To: Landmarks Commission
Legistar File 79099 [3701 Council Crest]
Commission meeting date: November 6, 2023 (Agenda Item 5)

**Susceptibility of black walnut tree (Lot 2 of the Old Spring Tavern)
to destruction due to proposed construction project**

Re: Old Spring Tavern property and proposed house at 3701 Council Crest
Legistar File ID No. 79099

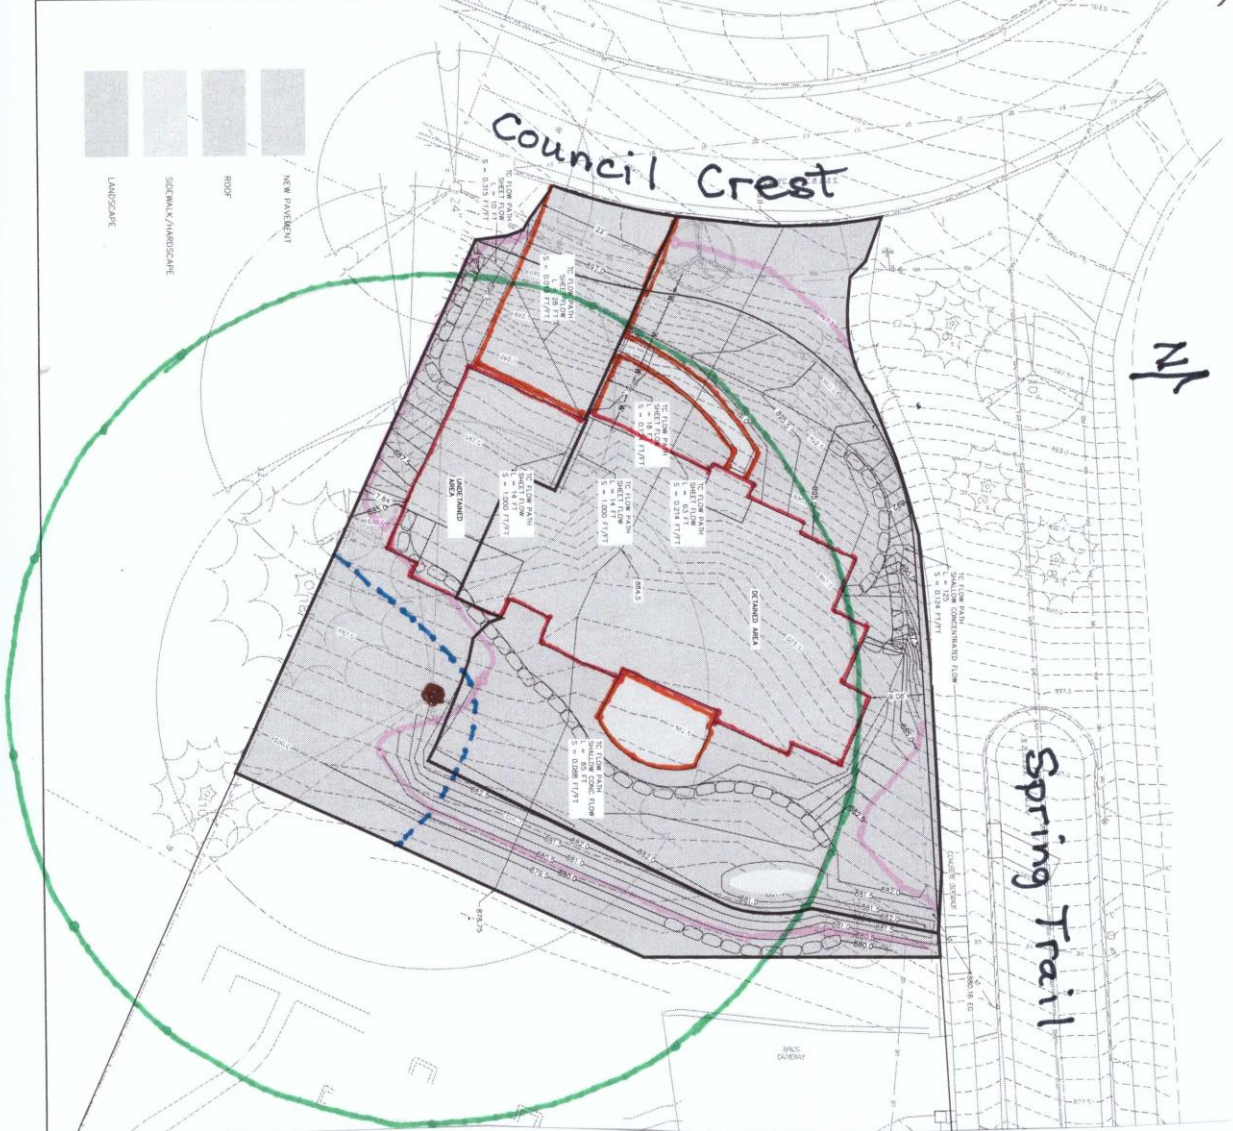
Comparing the TPZ to the project described in the proposed application

The **second diagram** attached to this memo contrasts the Tree Protection Zone that should be applied to construction on Lot 2 of the Old Spring Tavern site compared to the those areas of Lot 2 that would be: 1) excavated to contain the proposed structure as designed; 2) additional areas in Lot 2 that would be excavated for constructing the driveway, the brick paver walk, and the brick paver patio; 3) additional areas in Lot 2 that would be excavated or filled in order to create the topography behind the hydrology study that is included in the application; and 4) the tiny corner of Lot 2 shown on the landscape plan (that accompanied the April application) designated as the only portion of Lot 2 where “heavy machinery” will be kept off of the “walnut tree root zone.”⁴

My estimate is that a full 40% of the TPZ would be damaged by the proposed project. I believe this damage would translate to “certain destruction” of the black walnut tree that is central to (and provides context for) the site of the Old Spring Tavern.

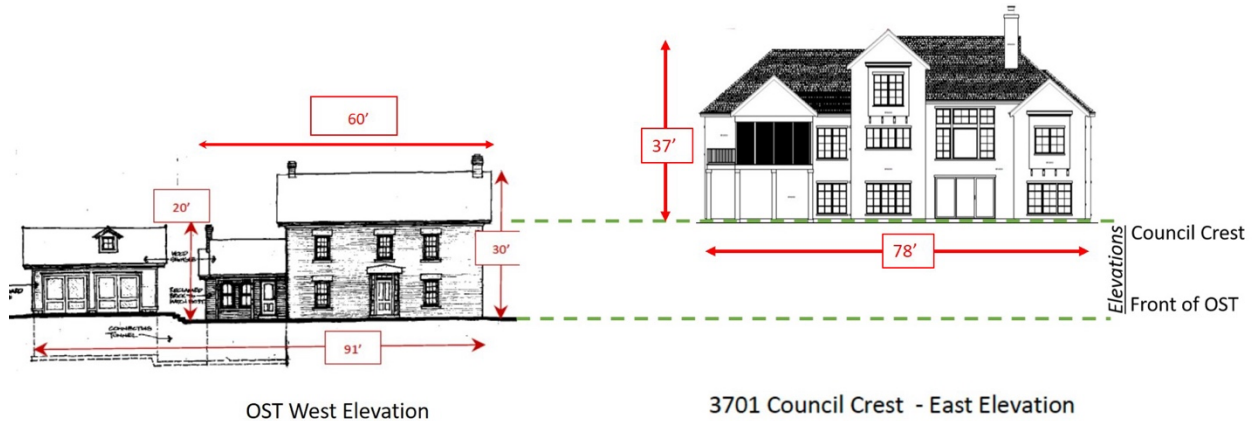
Standard 9. The new work shall be compatible in its massing, size, scale and architectural features to protect the historic integrity of the property. The proposed new house is significantly larger in square footage and mass than the historic Tavern. It is much taller and wider, and its bulk and height are accentuated by the fact that it is situated on a slope with its base ten feet above the base of the Tavern. From the front door and front windows of the Tavern, people would be looking at a three-story building with its base one story above the Tavern’s base, meaning its roofline would be four stories above the base of the front door.

The drawings below show how the proposed house is much taller than the Tavern, with its roofline 17 feet higher than the roof of the Tavern. It is much wider than the Tavern, and it is located only 26 yards from the front door of the Tavern. It is very rare to have another house located so close to the front door of an existing house. All of this makes it completely incompatible with the historic nature of the property.
